APPENDIX 10.0

**South Region High School No. 9
Final Recirculated Environmental Impact Report
Correspondence with the City of South Gate**

**South Region High School No. 9
SCH No. 2008041065**

Figure 2.1

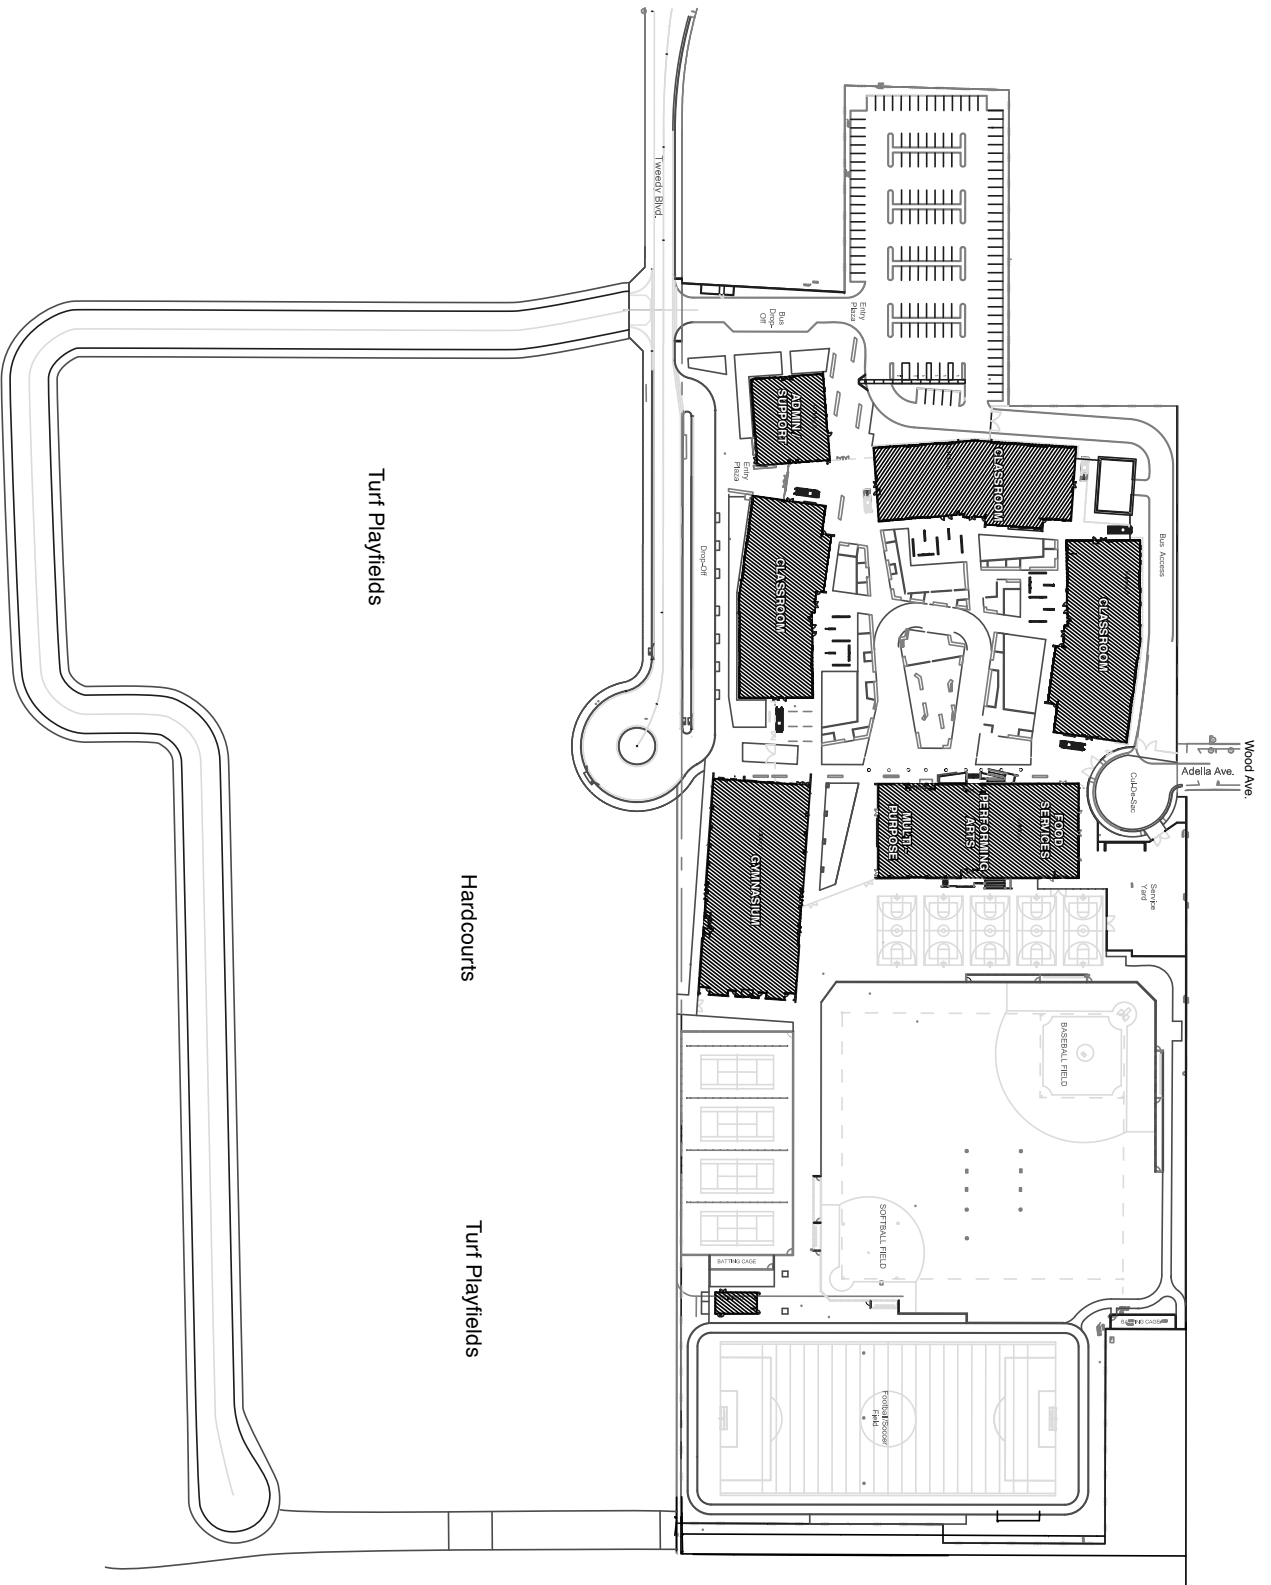
Alternative 1. As an alternative to the site design depicted in Figure 2.1 of the REIR, the City proposes that the southwestern-most portion of the site be utilized for student/guest/special event parking. This alternative will in no way disrupt or affect the layout of the buildings on the proposed campus but will avoid the severe traffic, pedestrian safety and noise impacts resulting from inadequate parking proposed for the Expanded Project. This alternative is depicted in Exhibit AA.

Alternative 2. As an alternative to the site design depicted in Figure 2.1 of the REIR, the City proposes that a portion of the existing Tweedy Boulevard at the eastern end of the site be utilized for student/guest/special event parking. This alternative will in no way disrupt or affect the layout of the buildings on the proposed campus but will avoid the severe traffic, pedestrian safety and noise impacts resulting from inadequate parking proposed for the Expanded Project. This alternative is depicted in Exhibit BB.

3. In Figure 2.1 on page 2-4, the proposed project shows that the service yard and food services building are located on the north end of the project site adjacent to Adella Avenue. Adella Avenue is a local residential road. To minimize impacts to the residential neighborhoods, all food delivery trucks and maintenance and operation trucks should access the proposed school from Tweedy Boulevard via the school parking lot.

4. In the fourth paragraph on page 2-5, the project description shall clarify that Chakemco Street east of the proposed perimeter road will be vacated by the City of South Gate. The vacation of Chakemco Street would require Chakemco Street to terminate at the proposed perimeter road, and thereby, create a T-intersection. This new intersection of the proposed perimeter road at Chakemco Street shall include, at a minimum, corner cut-offs and American with Disabilities Act (ADA) compliant curb ramps. The site plan on Figure 2.1 on page 2-4 shall be updated to show this new intersection.

Figure 3F.1
Analyzed Pedestrian Routes
and Volumes

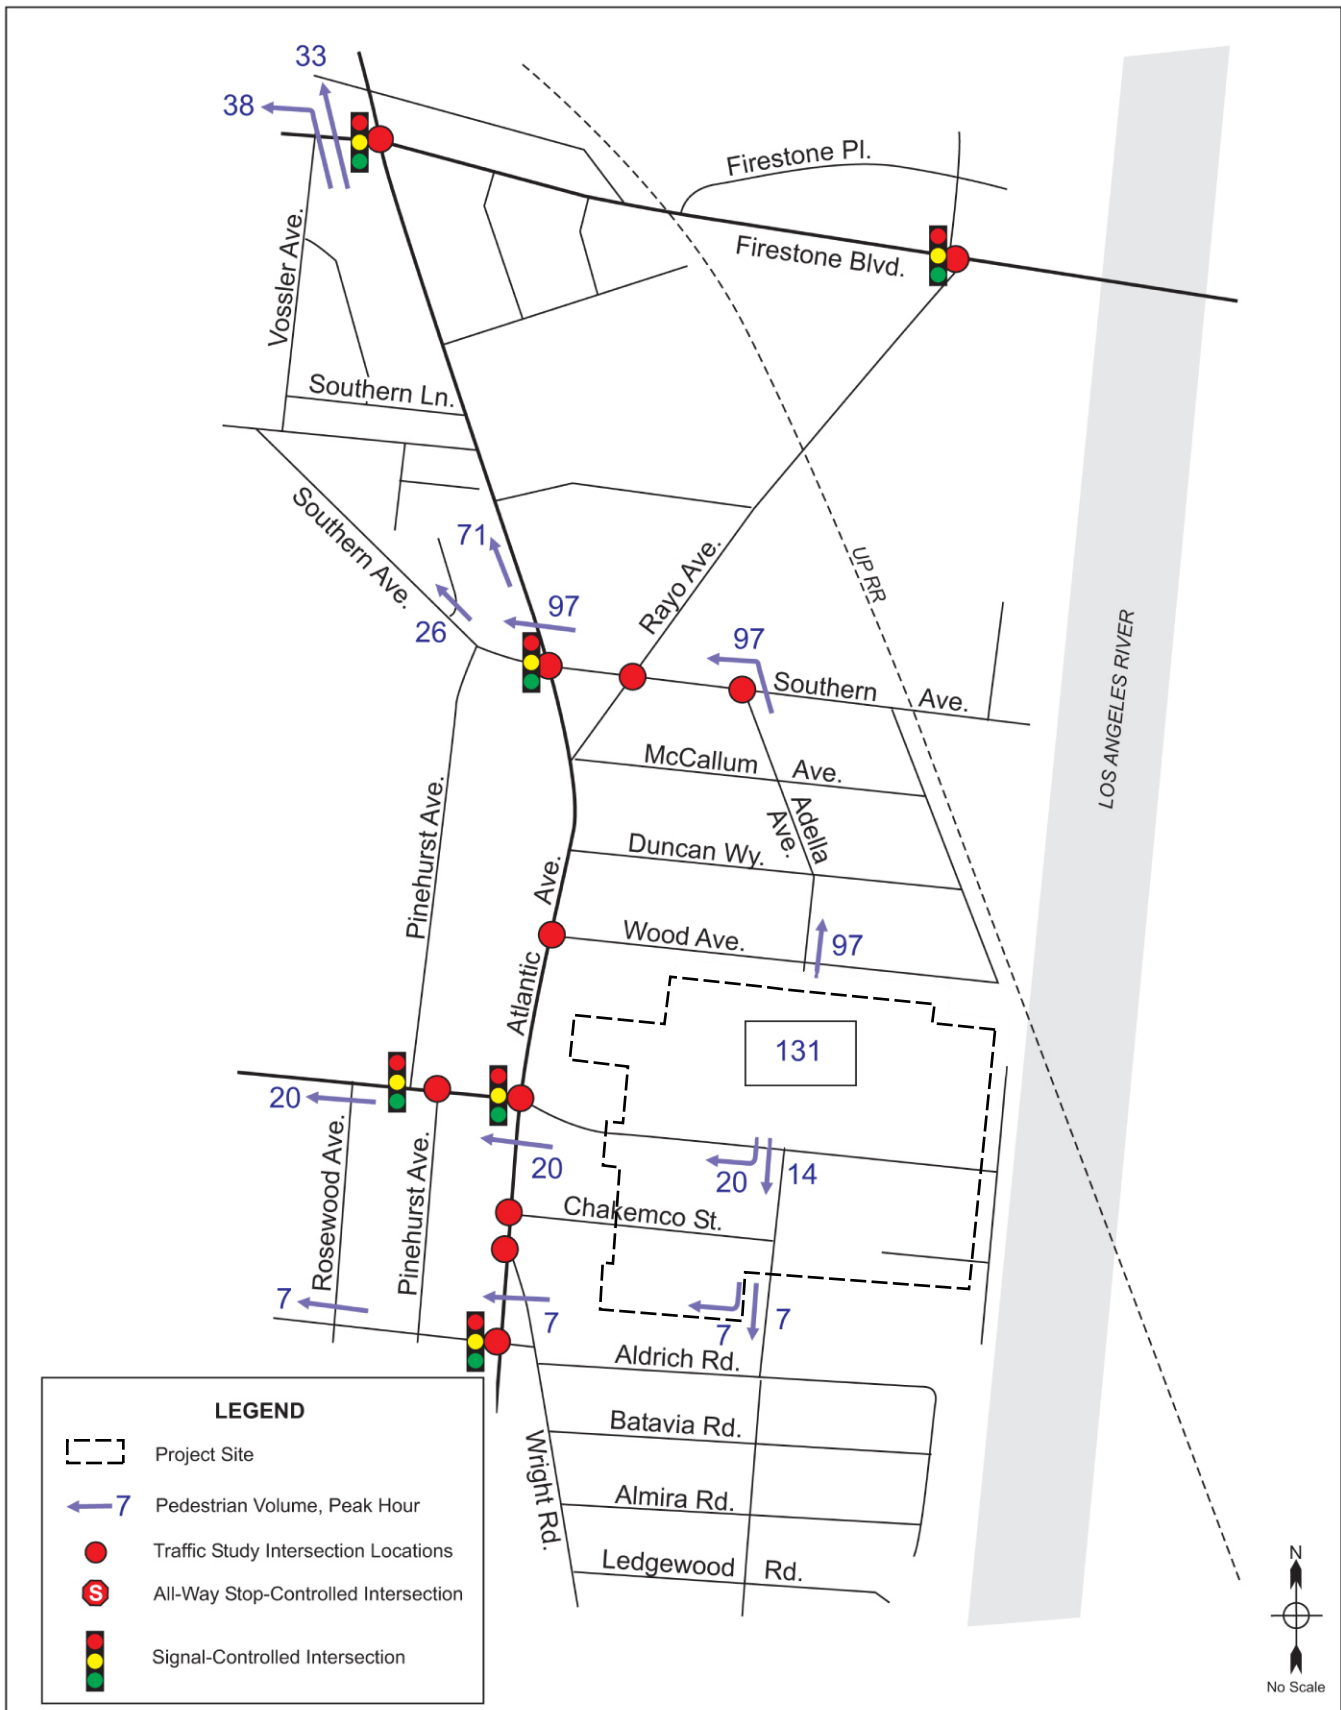
7. In Figure 3F-1 on page 3F-3, the intersection of Rayo Avenue at Southern Avenue should be identified as an all-way stop-controlled (AWSC) intersection.

8. As shown in Figure 3F.1 on page 3F-3, the proposed project forecasted that a total 131 students would walk to school, which is approximately nine percent (9%) of the total student population. However, the pedestrian trip generation of 131 students is low based on experiences and observations at South Gate and South East High Schools.

Figure 4 of the TIS and 3F-1 of the May 2009 Recirculated DEIR correctly identify Rayo Avenue at Southern Avenue with four-way stop control.

Figure 3H.1
Locations of Study Intersections and
Roadway Segments

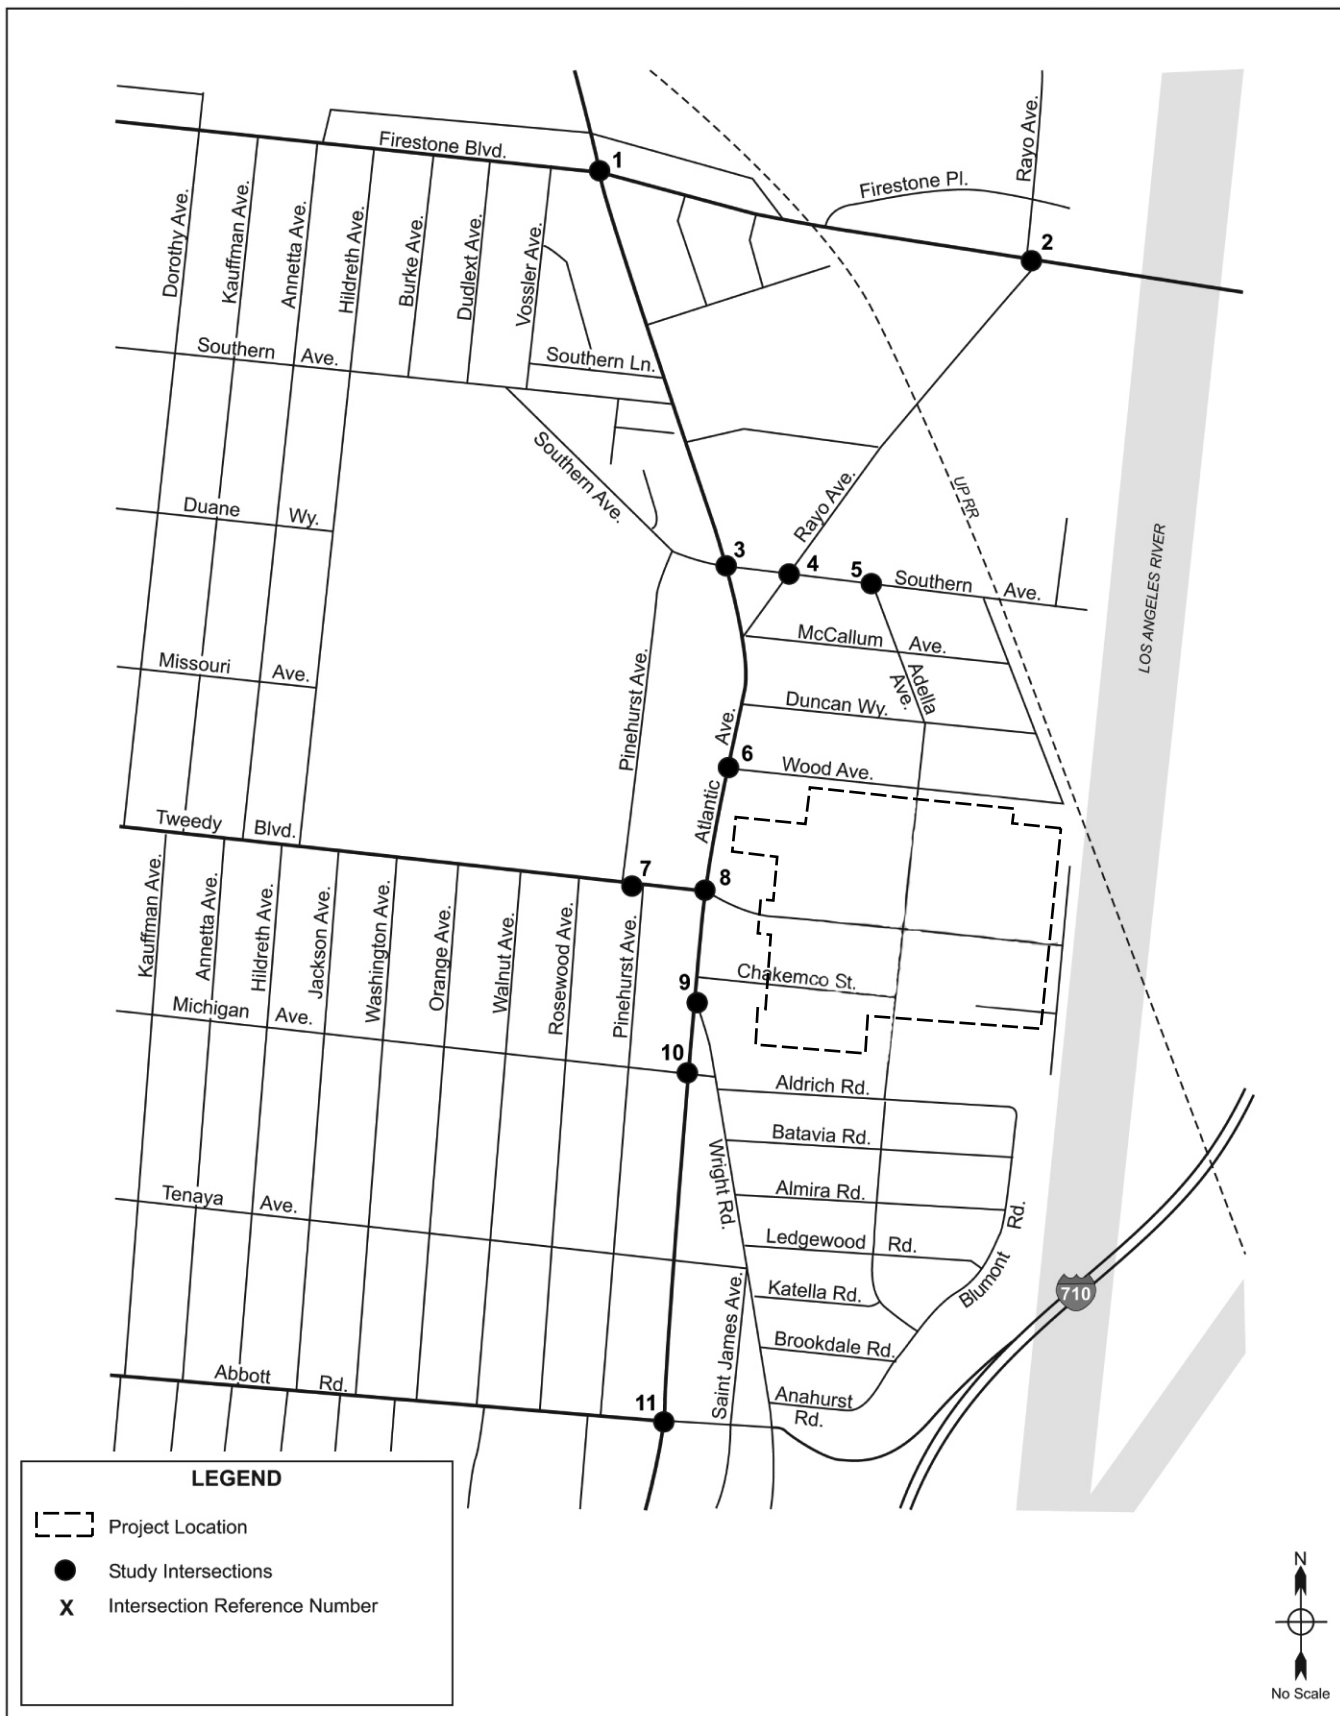
11. In Figure 3H-1 on page 3H-3, the intersection of Atlantic Avenue at Abbott Road was identified as a study intersection, but this intersection was not analyzed. E-11

In Figure 3H-1 on page 3H-3, the intersection of Atlantic Avenue at Abbott Road was identified as a study intersection, but this intersection was not analyzed. The study area figure was corrected in previous responses to comments. It was determined that analysis of this intersection was not necessary, as a majority of trips to and from the campus would originate in neighborhoods to the northwest and north of the proposed campus site, and from the Firestone Boulevard corridor and the I-710 interchange within that corridor. This intersection is located to the south of the proposed project site.
